Bath flood risk

Batheaston compensatory flood storage: review of BNES/34

Technical Note MAM6777-01

Figure 1 Typical cross-section (full site area)

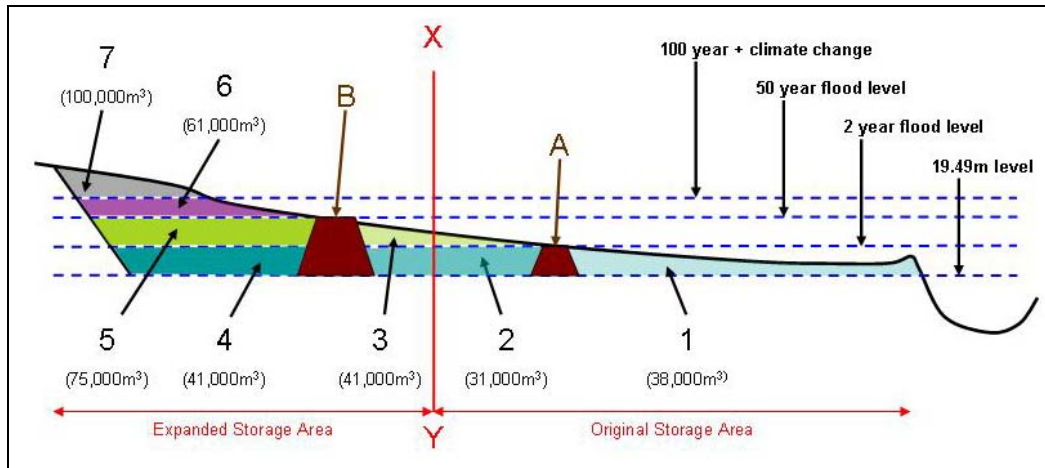
In addition, the extent of the original site is depicted by the X–Y line – see comments in Section 3.4 regarding a correction to this.

The brown areas that are shown depict possible non-excavated ground, with storage available behind them. This storage is in effect at the level of the top of the “bank”.

- The edges of the original site (X–Y lines) are shown incorrectly on 3 of the 4 WYG cross-sections (errors of up to 75m). The results presented by WYG substantially over-estimate the available storage volume for the original proposal. HR Wallingford estimates about 13,000m³ using the corrected alignments (the part of area 3 to the right of the X-Y line) compared to the original WYG volume of 61,500m³. (The large difference is because of the errors in the positions of WYG’s X-Y lines. These meant that too much of the higher ground was included in the WYG volume).

- Areas of lower lying ground beyond the WYG proposed non-excavated strip nearer the river (A) mean that volumes that would fill at the 2 year storm are overestimated by WYG. Much of this volume could already be full of water, that flows across from the lower ground to the east. (This is not depicted on Figure 1).

- Because of locally low ground levels the non-excavated strip should be substantially further away from the river than shown by WYG. The storage available at the 2 year level – water flowing over “bank” A into a pond area (area 2) - will therefore be less than presented by WYG.

Figure 2 Batheaston Storage Profile

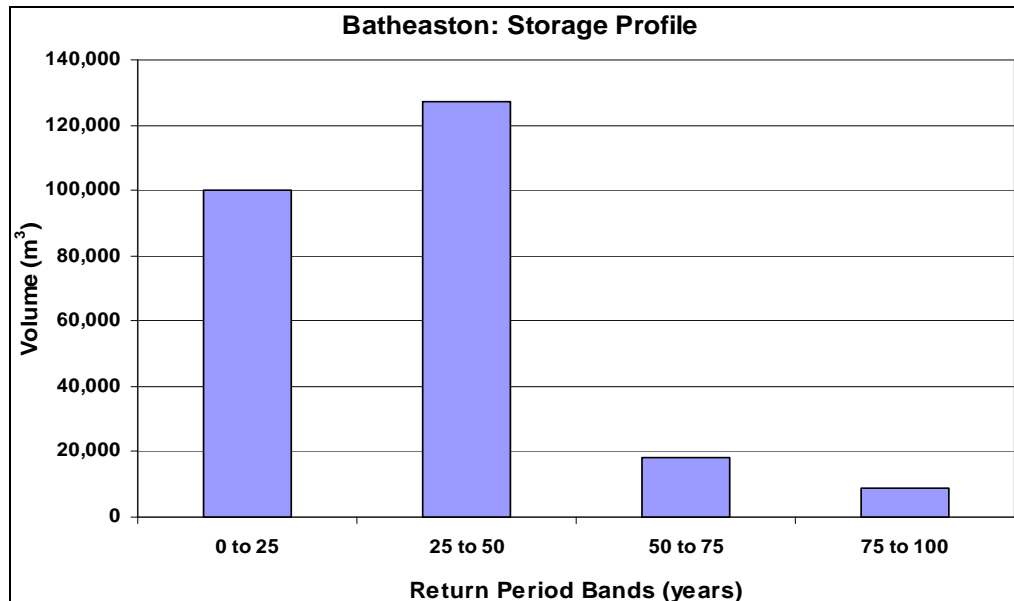
- A maximum of approximately 60,000m³ (area 6) is likely to be created at flood levels higher than the 1 in 50 year event.
- Figure 2 depicts the profile of the storage in 25 year return period bands (volumes between the 1 in 100 year and the 1 in 100 year plus climate change levels are not included, as the current return period for this higher level is not known). Available storage is concentrated at the lower levels.

- With the proposed scheme there is therefore a major imbalance in the storage provision. Even with the higher flood storage from the Park and Ride site there will be insufficient volume at higher levels to compensate for much of the lost storage in Bath, at equivalent levels.
